# Differences Between Rigid and Flexible Air Barriers

CE 110 and 112 relate to the air leakage/air barrier section and the list of materials that are deemed to comply as an air barrier. CE 110 & CE 112 propose to remove the words “fully adhered” from item number 11, meaning that ANY single ply membrane would be deemed to comply as an air barrier.

# Fully Adhered Single-Ply

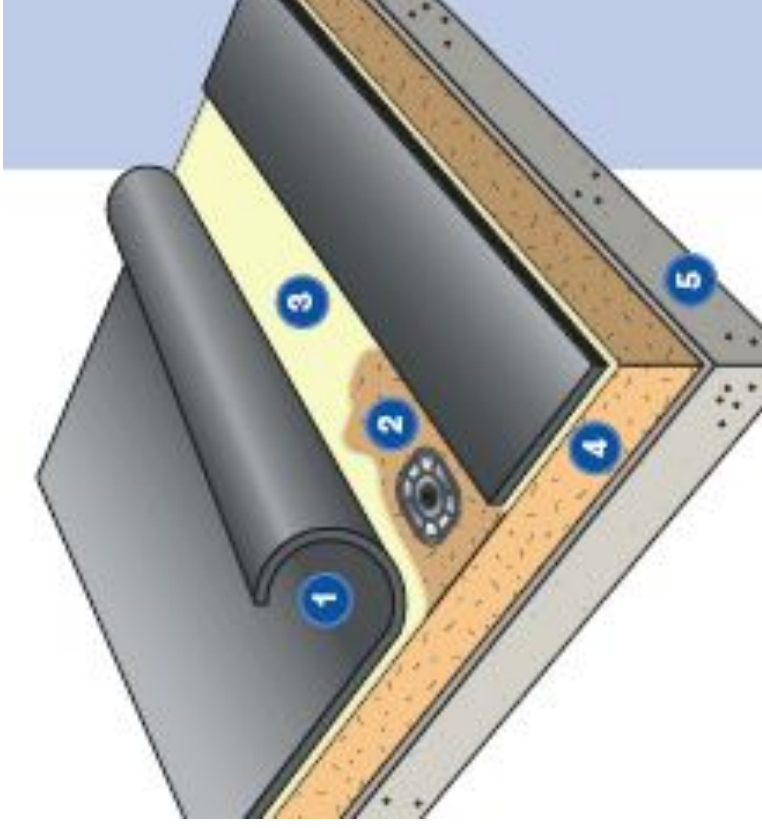
This is a fully adhered single ply roofing system. It functions as a rigid air barrier. Note that there are no gaps in contact between the membrane and the rest of the assembly.

# Mechanically Fastened FLEXIBLE

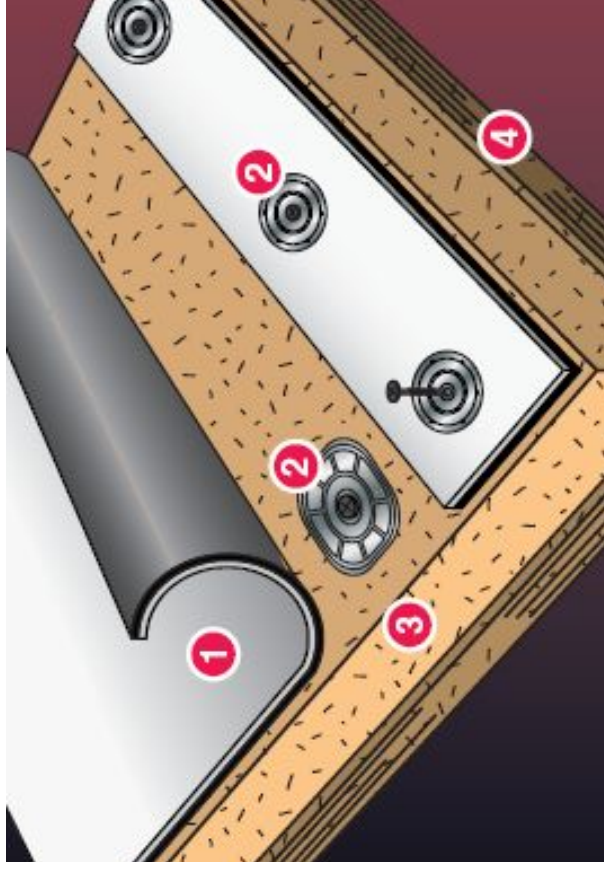
Leaving a space between each seam where the membrane is not secured to the insulation means that it is flexible. In other words, no matter how skillfully those seams are secured, there will always be flexibility of the membrane between the seams because the membrane is not secured at all points of contact.

# Mechanically Fastened FLEXIBLE

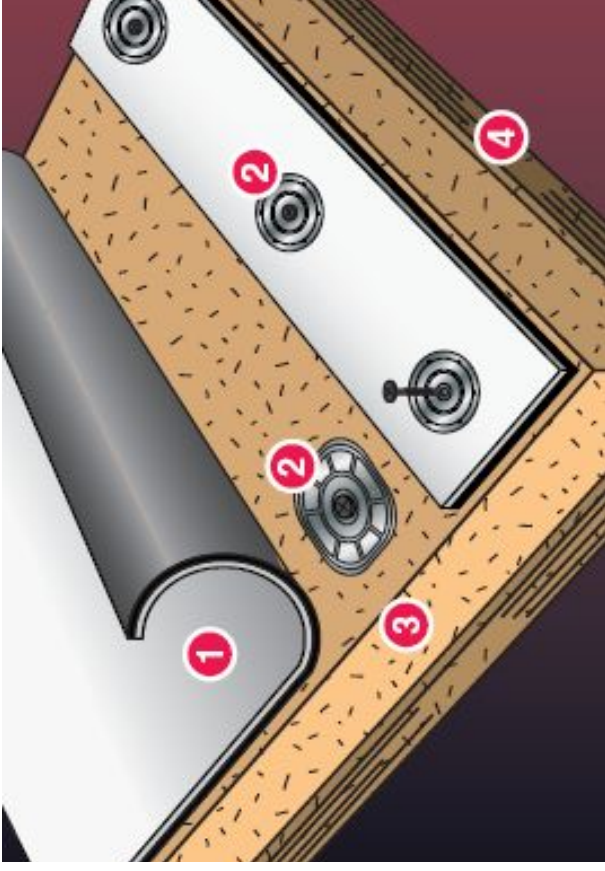
This flexible air barrier allows air to intrude ABOVE the deck and into the roofing assembly. It is for this reason, this air intrusion above the deck and the resulting negative impact on the energy efficiency of the building, that we oppose CE 110 and 112.

A flexible air barrier can cause energy loss. By removing the words fully adhered you will permit a flexible air barrier to be installed and give the misimpression that the method of installation is irrelevant to energy efficiency.

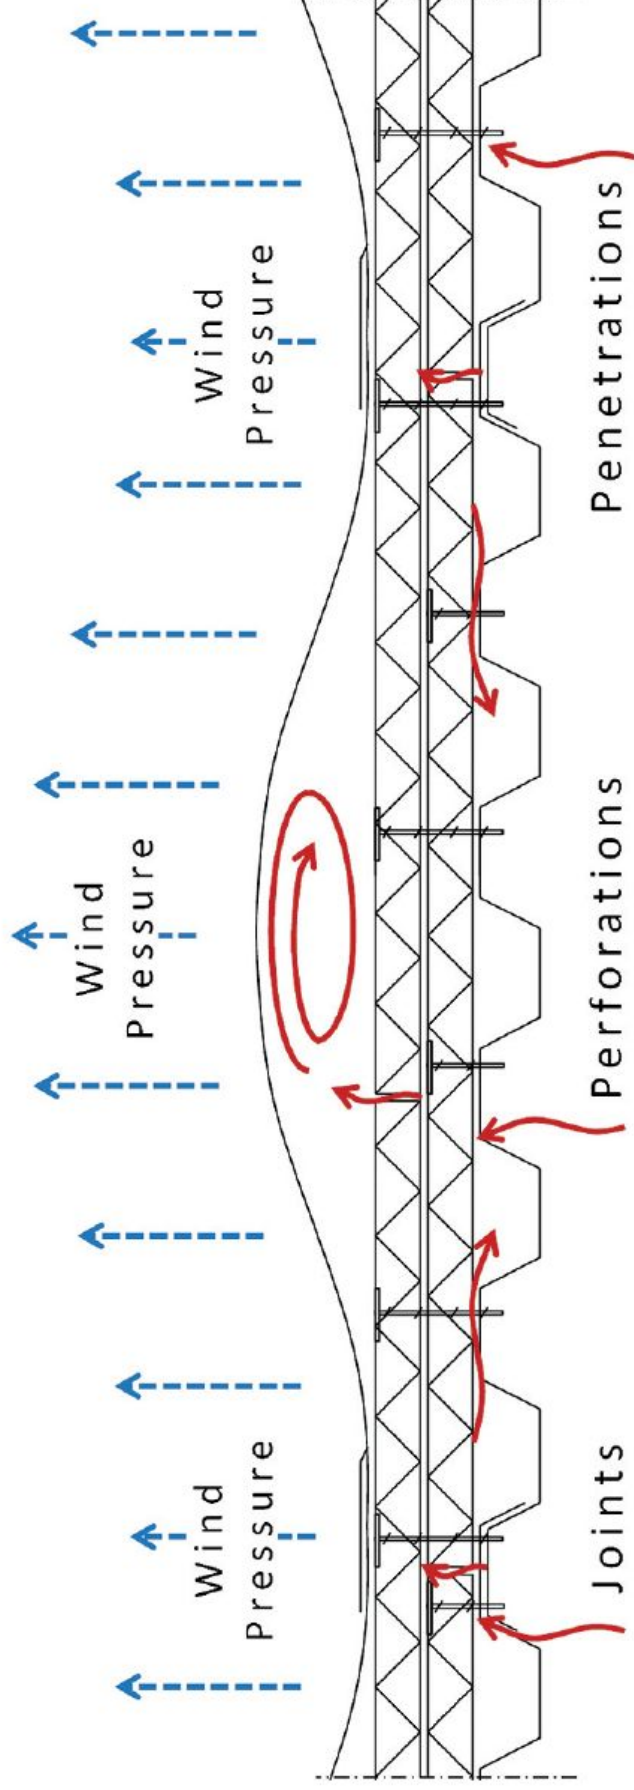
This is a cross section of what is happening in the video you just saw. Basically wind creates pressure differences on the roof which causes the membrane to flutter or balloon. Air intrusion may occur in overlapping joints of the deck, penetrations, or perforations.

ORNL studied this very issue, and found that there is a 3-8% energy penalty for mechanically fastened systems because of air intrusion – because warm air is pulled into the assembly, cools, and then falls again and has to be re-heated.
